Project Name & Address: 240 W Gilman Street

Application Type(s): Certificate of Appropriateness for a land division

Legistar File ID # 66288

Prepared By: Heather Bailey, Preservation Planner, Planning Division

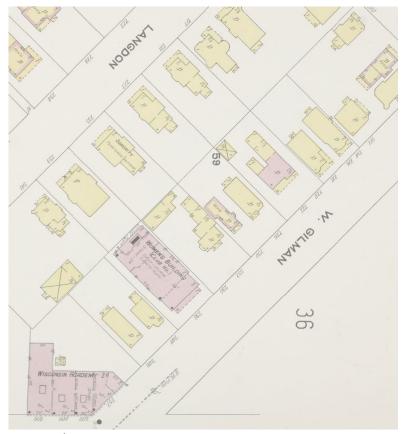
The applicant is requesting a Certificate of Appropriateness to divide an existing lot at 240 W Gilman into two separate lots. The landmarked property would remain on a parcel approximating its historic dimensions and the current surface parking lot would again become its own parcel. The submittal materials show an unresolved underlying lot line where there used to be two separate parcels. The proposal would largely maintain that previous separation with a slight jog near the rear of the property to accommodate Zoning setback standards for the existing historic structure.

consolidating for larger developments. Once the residential structures at 232 and 236 W Gilman were demolished (between 1908 and 1942), it appears the lot remained vacant and subsequently became a surface parking lot. Those two lots are currently considered one parcel and the proposal is to divide them into separate parcels again.

Staff believes that the standards for granting a Certificate of Appropriateness are met and recommends the Landmarks Commission approve the request as proposed.
